HOWARD COUNTY HISTORIC PRESERVATION COMMISSION

July Minutes

Thursday, July 9, 2020; 7:00 p.m.

Figure 1 - Proposed projecting sign

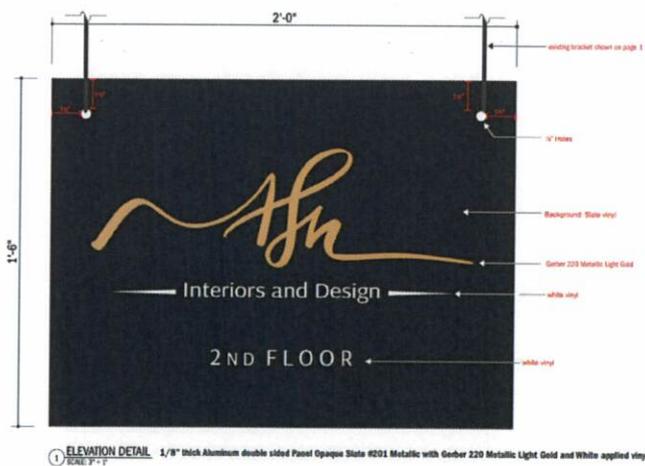
The signs comply with the general guidelines. The first sign will only contain the name of the business and a reference to business location on the second floor of the building. The second sign also contains limited text and will only contain the business name and phone number. There are only three colors used in each sign, and they will use the same color scheme.

The first sign will be hung from an existing metal bracket and complies with the Guideline recommendations. The signs will both be aluminum. While not as evident on a flat mounted sign, the modern material is evident on a projecting sign as it lacks the traditional depth found in a wood sign, MDO sign or HDU sign.

Mr. Reich said he did not have a problem with either of the signs as they both comply with the Guidelines; they are the right size and include the correct number of colors. Mr. Reich said he is not worried about the sign on the door as it is set back and recessed. The door sign does not look out of place to him. Mr. Reich said it would be nice if the sign could fit within one of the cross members on the panels but finds both signs to be nice as they coordinate. Mr. Reich said he was okay with the proposal.

Staff Recommendation to the HPC: Staff recommends the HPC approve sign #1 as submitted. Staff recommends the HPC provide advice on the design of Sign #2, the door sign; or approve if the HPC finds the sign complies with the Guideline recommendations.

Figure 7 - Proposed partial side elevation looking west

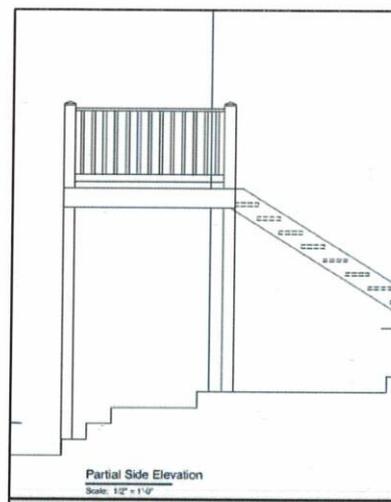
Ms. Zoren said she agreed with Mr. Reich as far as the materials and wanted Mr. Reich's opinion on the column spacing as the Applicant has changed the spacing. The proposal shows paired columns with a single column on the end. Ms. Zoren said that all other porches on Main Street have very regular column spacing and the way the application had the columns paired, they were not close enough to be considered a pair. Mr. Alghatrif said he spaced the columns as they were in order to highlight the windows on the façade of the building façade and not block them, but could change the columns.

Ms. Tennor said she agrees with the Applicant, it makes sense to have the columns arranged for the window spacing. When she reviewed the application originally, there was concern that the increase of the depth of the porch by two feet would change the streetscape. Ms. Tennor said she no longer has the concerns with the expansion and said the historical photo submitted with the application strengthens the Applicant's case for his request. Ms. Tennor said she liked how the way the stair was handled and that the design has come a long way. Ms. Tennor said she appreciated the inclusion of information that was submitted with the new application.

Figure 11 - Existing conditions

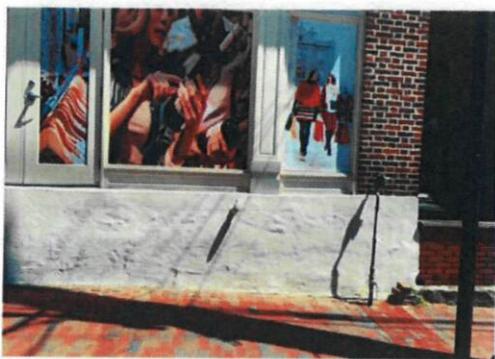
Ms. Tennor said the concept was great, but the execution is critical due to the location and scale of the two areas for the mural. Ms. Tennor said the samples that were submitted to the Commission do not match very well to the photoshop examples that were submitted. Ms. Tennor asked if the stone work will look like the sample submitted, which is more rusticated. Ms. Tennor said she did not feel they achieved the trompe l'oeil appearance. Ms. Tennor said that when people are close to the elevations of the wall, being more convincing would help and enhance their effectiveness. Ms. Tennor said the idea of putting little creatures to be found was a great idea and that the execution will need to be all that more convincing and detailed.

Ms. Tennor added for the brick work, the mortar on the sample seemed way too white, with the intent to match the existing brick work. Ms. Egan said the muralist is the same artist who did the brick work on the side of Sweet Elizabeth Jane and intends for the brick work to match the building.

Ms. Tennor said the proposal could be a nice addition to Ellicott City, but the execution is critical. The visitor will have a more intimate relationship with these two walls than other murals where people may stand back to view. Ms. Egan asked if the Commission would like her to provide better samples to staff. Ms. Tennor said she would like to see better examples than what was submitted.

Ms. Zoren said she objected to the application when it went through the Minor Alterations process because it was more of a faux finish than a mural. Ms. Zoren said she thought the concept was charming, but also a juxtaposition in the only place that has truly natural elements, which could end up

Motion: Ms. Tennor moved to approve the application with additional artwork samples submitted to staff to look at. Mr. Reich seconded. The motion was passed 4-1, with Ms. Zoren opposed.

Figure 21 – Proposed rear (South) elevation, Sheet A6.

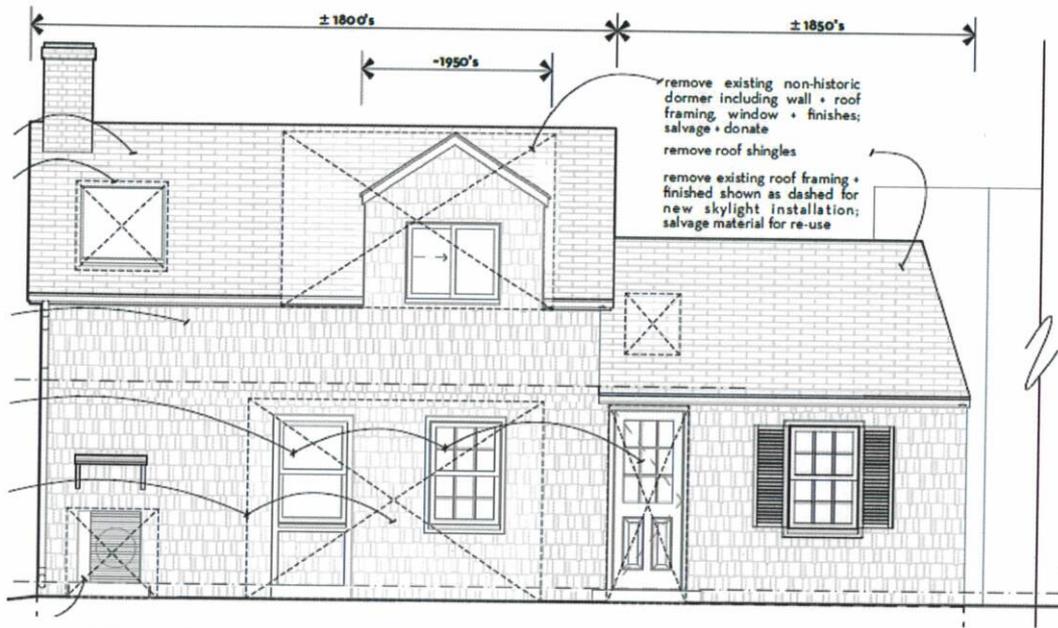
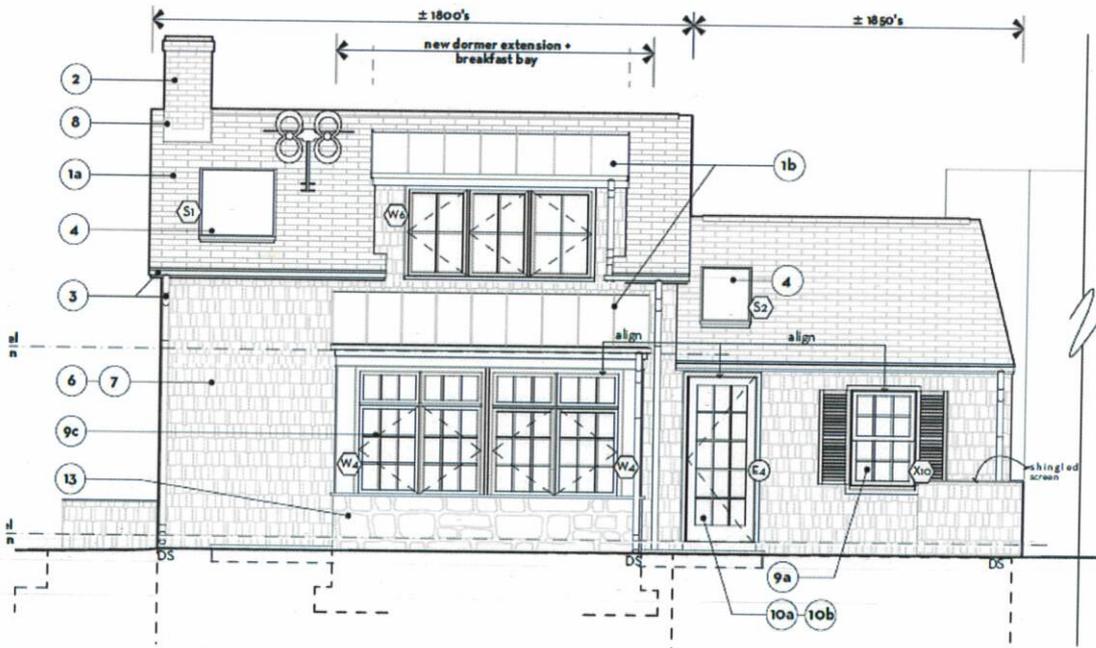
- 22) Skylight – Remove the existing skylight on the original portion of the building (SW side) and install a new Velux skylight (referenced on the drawings as S1). Install a new skylight on the SE side/1880s addition (referenced on the drawings as S2).

- 23) New Rear Addition – Remove the existing windows as shown on the drawings (1/1, 6/6 and 6/6). Construct a new addition in this location. The addition will have a stone foundation, 15-light Marvin wood French door, painted Benjamin Moore, HC-181 Heritage Red, and a metal standing seam roof. The stone foundation will consist of a 4" stone veneer on CMU block base from reclaimed granite onsite or equal; size, coursing, layout pattern, mortar color, texture and tooling to be compatible with existing stone wall: new work to be consistent with the historic stone wall.

- 24) Roofing to be new Double Lock 1" standing seam metal roof by Riverside Sheet Metal; color 'UNDAR' Midnight Bronze; 18" wide panels. There will be four 9-light casement windows, each with a three light transom above. All trim to be Western Red Cedar, painted white.

- 25) Dormer Alteration – Remove existing modern dormer. Construct a shed dormer, using a standing seam metal roof and three 4-light casement windows. Roofing to be new Double Lock 1" standing seam metal roof by Riverside Sheet Metal; color 'UNDAR' Midnight Bronze; 18" wide panels.

Figure 22 - Rear site alterations and repairs

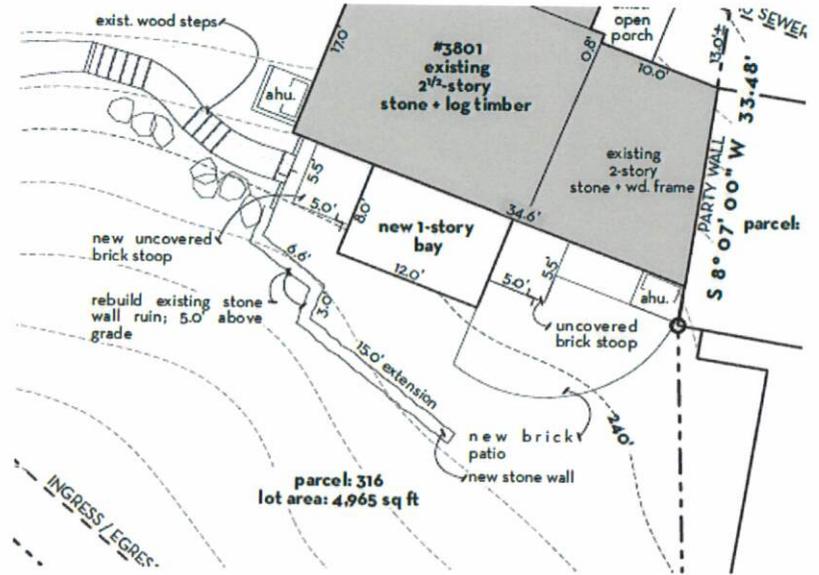
- 29) Two new brick stoops will be installed, one either side of the rear addition, in the location of the exterior doors. The stoops will each be 5-feet 5-inches deep by 5 feet wide.
- 30) There is an existing stone wall ruin, which the Applicant proposes to rebuild. It will be five feet above grade. The existing wall runs 6-feet 6-inches in length and then turns for another 3 feet. The Applicant proposes to add a 24" high and 10-12' long extension, also to be built in stone. Details on the new portion are not available yet.
- 31) Construct a new brick patio behind the SW/1880s portion of the house.
